09 - 2011  
BTD141, BTD141Z, BTD141H2  
18V IMPACT DRIVER KIT

**SERVICE CHANGES**

**1. Changes on Hammer Case Cover and Bumper**

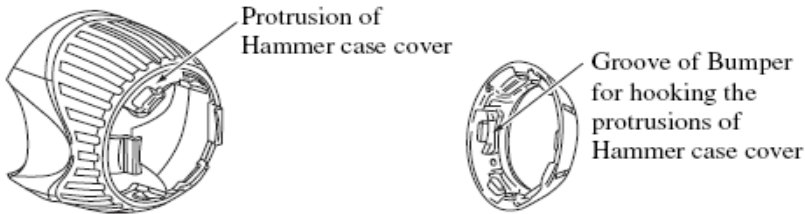
Item No.	Description	Type 1	Type 2
14	Bumper	424015-7	424369-2
15	Hammer Case Cover	450585-0	452409-6

Above parts are completely interchangeable as a set.

Type1: Bumper is hooked with the grooves of Hammer case.

Type2: Bumper is hooked with the protrusions of Hammer case cover as illustrated below.

**2. Changes How to Assemble Carbon Brushes**

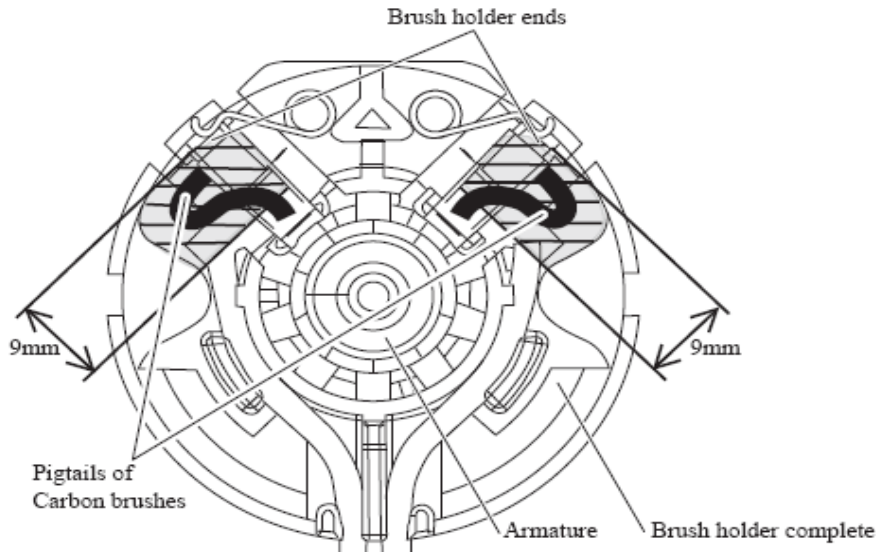
Item No.	Description	Type 1	Type 2
36	Carbon Brush	194427-5 (W/O ORIGIN)	195021-6 (W/ ORIGIN)

Do not protrude the pigtails of Carbon brushes from the specific spaces.  
Refer to the following illustration.

### 3. Changes on Hook

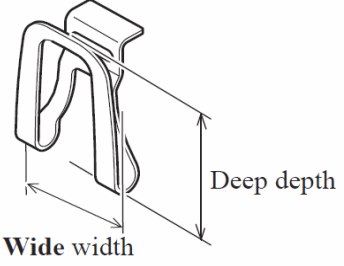
Item No.	Description	Type 1	Type 2
A05	HOOK	324705-1	346449-3
A05	HOOK	346034-2	346449-3

Width has been changed wide size to narrow size

Type 1	Type 2
 <p><b>Wide width</b> (324705-1)</p>	 <p><b>Narrow width</b> (346449-3)</p>
 <p><b>Wide width</b> (346034-2)</p>	 <p><b>Narrow width</b> (346449-3)</p>
